1958 Corvette: Service Bulletin: Electric Windshield Wiper Information

Subject: Electric Windshield Wiper Information
Model and Year: 1958 Passenger Cars and Trucks
Source: Chevrolet Technical Service Bulletin
Bulletin No: DR #359
Section: I
Date: May 28, 1958

FIGURE #1.

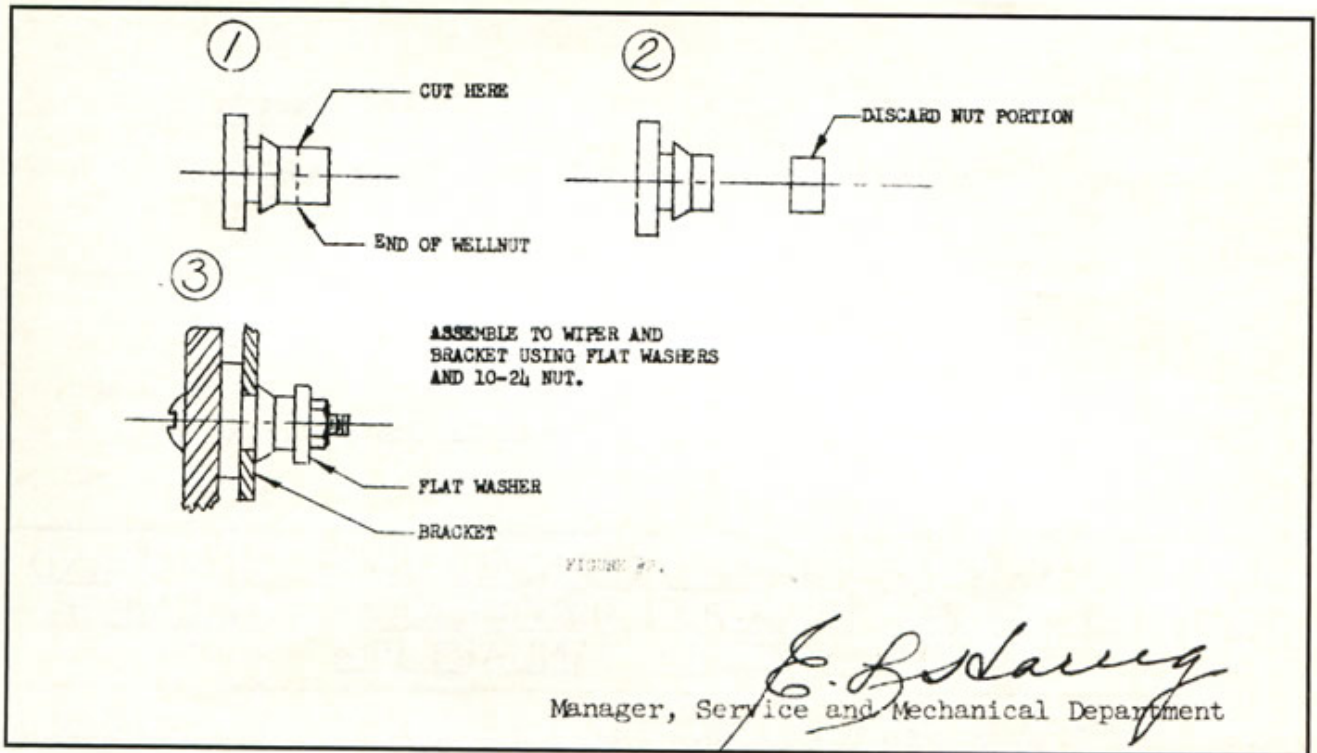
In some cases the wiper motor, after being shut off, may over travel the effective length of the parking cam and continue to run in a reverse direction. This condition may occur even though the blades are properly positioned as covered in TSB #508, DR #359.

A parking spring has been released for production and service which enables the motor to shut off without depending on the resistance of the wiper blades. The spring is designed to clear the revolving arm in the "ON" position and stop the arm in the "PARK" position when switch is turned off. Figure #1 shows installation of parking spring.

If the right hand blade slaps against the moulding excessively even though the blade is correctly positioned and parks properly, the upper cam stop is probably bent or broken. This damage can occur if the mechanism is coated with ice when the wiper is turned on.

A more durable replacement cam stop is available for service. Figure #1 shows details of installation. The existing tab must be bent flat before installation of the new stop.

SKETCH SHOWING INSTALLATION OF PARKING SPRING AND CAM STOP ON 1956 ELECTRIC WINDSHIELD WIPERS.
